TE Connectivity

Product Change Notification: PCN-25-256569

Single Wire Seal

Adding CD 281934 Alternate CAV-ID design

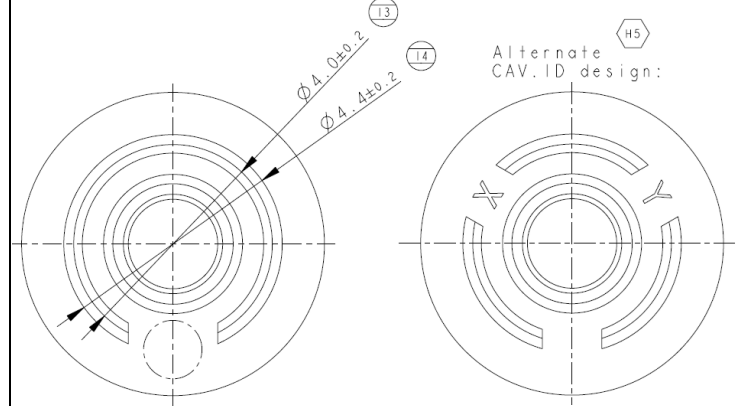
End-face: no CAV.IDs.

Alternate design for CAV.IDs.
